# Access Compliance Report

## Public Rights-of-Way

### (Curb Ramps)

Intersection ID: 16675	Main Street: IBM_DR	Cross Street: UNIVERSTIY_POINTE_BV	Location: NE
ADA ID: EFA41A9DC580	Ramp Type: Perp	Initial Pass/Fail: Fail	Overall Compliance: No
		Severity Score: 1.25

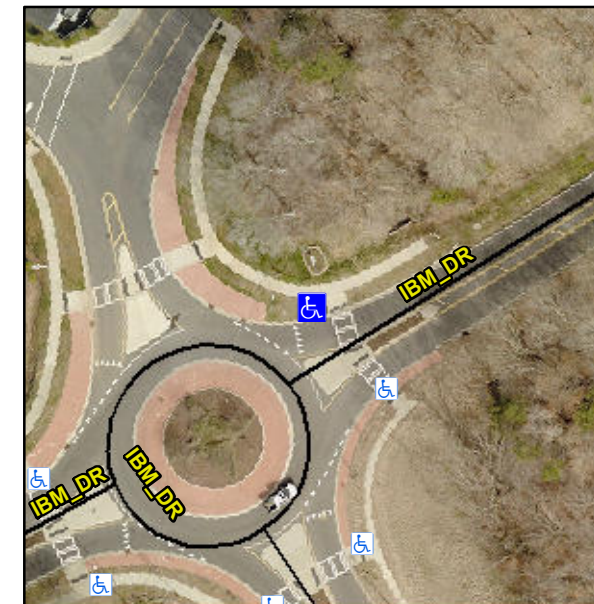
**R304.5.3**

Compliance	Description	Data	Compliance	Description	Data
N/A	Ramp Length (in)	97.0	Yes	Ramp Slope (%)	7.4
Yes	Ramp Width (in)	118.0	No	Ramp XSlope (%)	2.1
N/A	Flare Type LT	N/A	N/A	Flare Type RT	N/A
N/A	Flare Slope LT (%)	N/A	N/A	Flare Slope RT (%)	N/A
N/A	Flare Traversable LT?	N/A	N/A	Flare Traversable RT?	N/A
N/A	Landing Length (in)	N/A	N/A	DWS Provided?	N/A
N/A	Landing Width (in)	N/A	N/A	DWS Contrast?	N/A
N/A	Landing Slope (%)	N/A	N/A	DWS Length (in)	N/A
N/A	Landing X Slope (%)	N/A	N/A	DWS Full Width?	N/A
N/A	Landing Curb? (Y/N)	N/A	N/A	DWS Offset (in)	N/A
N/A	Shared Landing?	N/A			
N/A	Gutter Ponding?	N/A	N/A	Gutter Slope (%)	N/A
N/A	Gutter Lip Ht (in)	1.5	N/A	Gutter X Slope (%)	N/A
N/A	Painted X Walk1?	No	N/A	Painted X Walk2?	N/A
	X Walk 1 Direction	To S		X Walk 2 Direction	N/A
N/A	X Walk 1 Width (in)	N/A	N/A	X Walk 2 Width (in)	N/A
	X Walk 1 Slope (%)	2.7		X Walk 2 Slope (%)	N/A
	X Walk 1 X Slope (%)	1.0		X Walk 2 X Slope (%)	N/A

**Remove & Replace Entire Ramp.**
